Access Compliance Report

Public Rights-of-Way

(Pedestrian Signals)

Intersection ID: N/A	Main Street:	Cross Street: N/A	Location: N/A
ADA ID: C54245D89EB9	Signal Type: One Push Button-APS	Overall Compliance: No	Severity Score: BTN 1: N/A BTN 2: N/A No BTN: N/A
Codes/Mitigation Info/Possible Solution		Field Measurements/Component Compliance

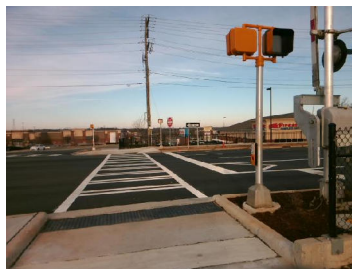
Possible Solutions: Remove & Replace
Replace APS Button With New APS Button.
Remove and Replace Clear Space.

PROW/ADA: R404.7.3, R404.7.2, R209.1,
MUTCD 4e.10
